WEIR ENGINEERING, LLC

Re: Title V Inspection & Reporting - July 31, 2010

Title 5 Official Inspection Form

#88 High Point Road

Sketch Of Sewage Disposal System: Provide a sketch of the sewage disposal system including ties to at least two permanent reference landmarks or benchmarks. Locate all wells within 100 feet. Locate where public water supply enters the building.

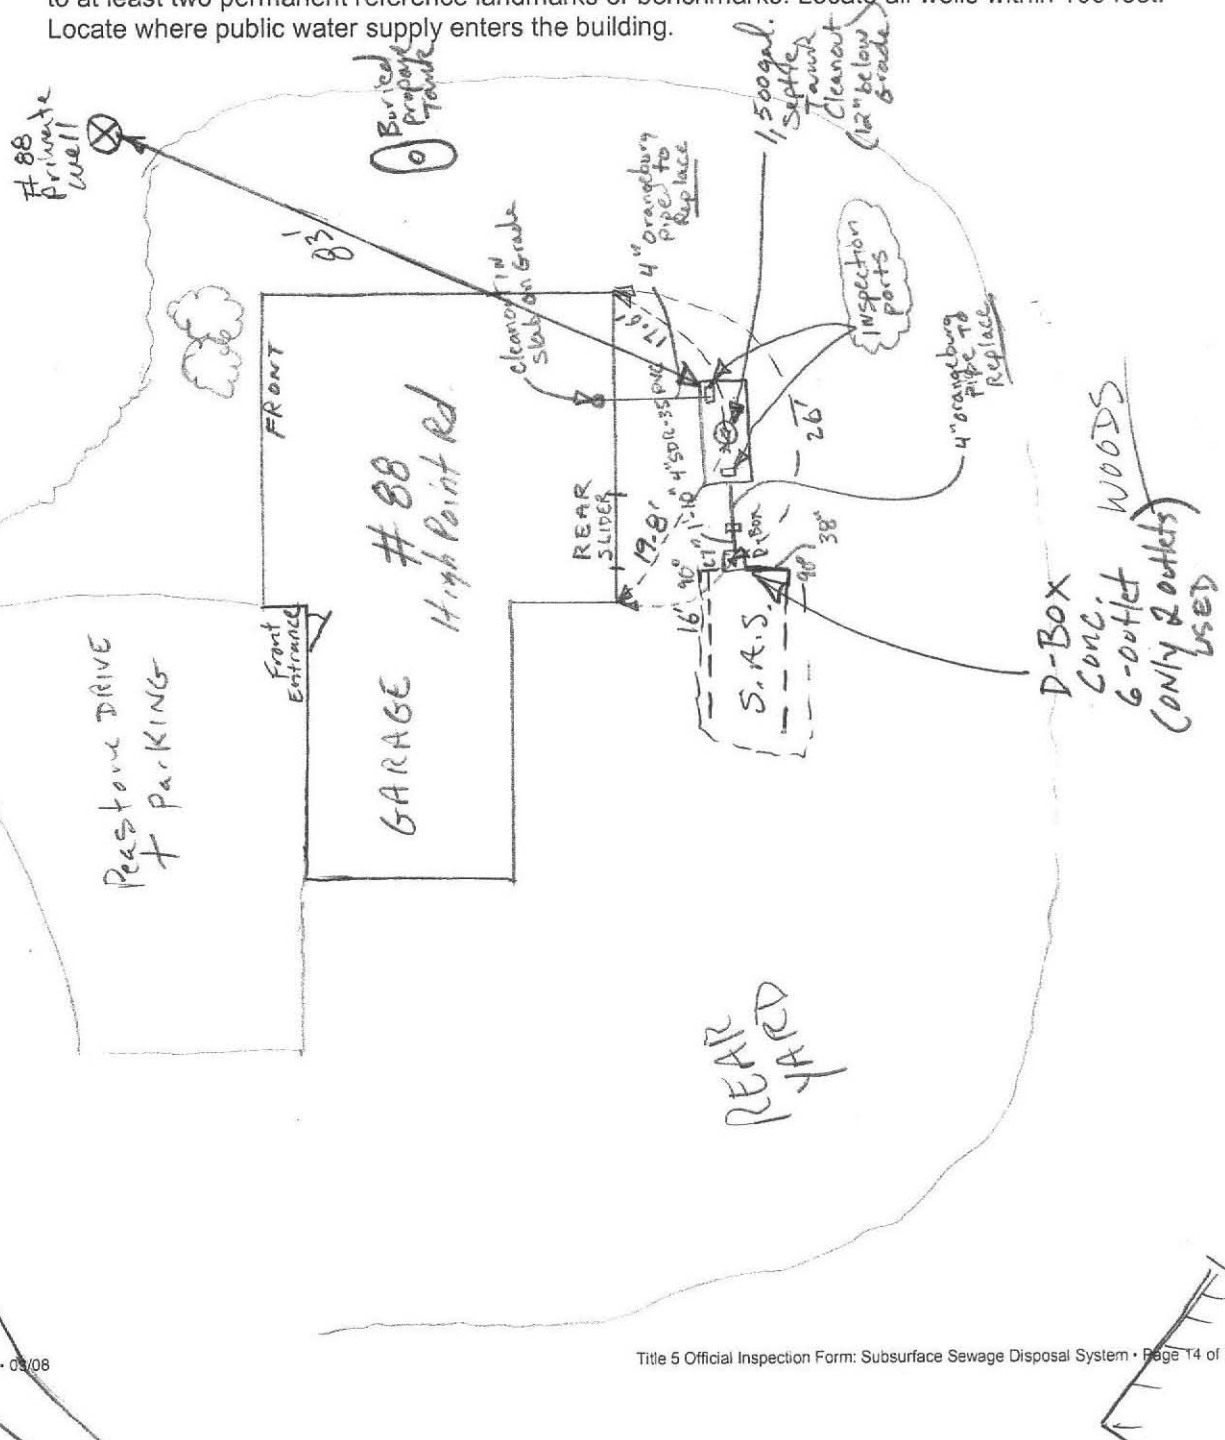
Recommend homeowner have the Orangeburg pipe replaced with new 4" Sch. 40 PVC soil pipe from house to septic tank and septic tank to D-Box inlet while house renovation work is on-going.

The Inlet & Outlet baffles are showing signs of deterioration so recommended to home owner that 4" Sch. 40 PVC inlet and outlet tees be installed per 310 CMR 15.000 requirements at the same time as the soil piping repairs are made. Also, recommend an outlet effluent filter be installed to maximize longevity of the existing S.A.S. Notes: The bottom of the proposed Inlet tee shall be a minimum 10" below the flowline of the tank and Outlet tee approximately 20" below. The existing spetic tank is 1,500 gallons and sets close to level. Tank checked - Statically Water Tight.

Precast Concrete D-Box was replaced new about 4 years ago. No evidence of solids carrying over, No evidence of leakage, D-Box sets close to level. 2 of 6 D-Box outlet knockouts utilized. (2) E-Z Outlet levelers were adjusted to balance flows evenly to S.A.S. as part of this inspection.
